Sheet: /
File: voltage_sensor.sch

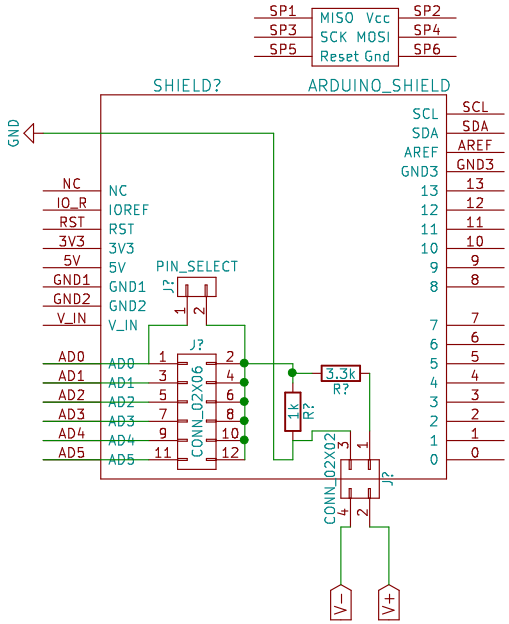
The 3.3k resistor is not connected to GND at either end!
